**CDL Response 16/02/2026 to Panel's Working Draft Conditions
For Comment released 23/01/2026**

ARATAKI PROJECT CONDITIONS OF CONSENT

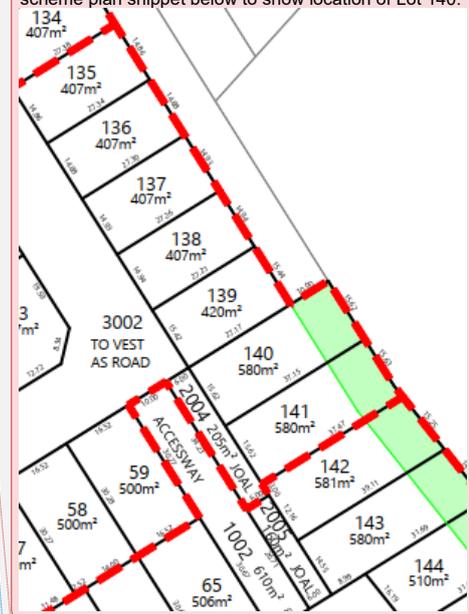
Commented [CDL55]: Requested amendment: This selection of lots should also include Lot 140 which has a boundary with the Reserve land. This was an oversight in the original drafting of this condition. Please see scheme plan snippet below to show location of Lot 140:

Commented [CDL58]: Requested amendment: As per above comments, this list should include Lot 140 which has a boundary with the Reserve land. This was an oversight in the original drafting of this condition. Please see scheme plan snippet below to show location of Lot 140

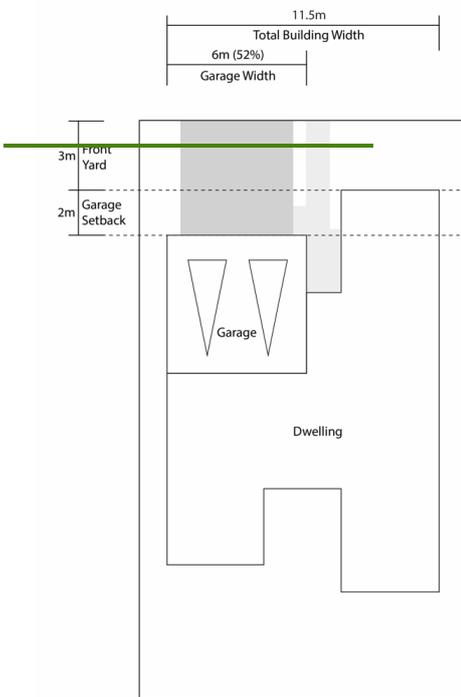
Commented [CDL59]: Requested amendments: Lot 30 has accidentally been included in the list of applicable corner lots. Lot 30 will have direct access to Arataki Road and is adjacent to a JOAL - it is not a corner lot. Lot 48 should have been included as this is a corner lot to an Access Road. See plan snippet below.

Commented [CDL60]: Requested amendments: As above comment re corner Lot 48.
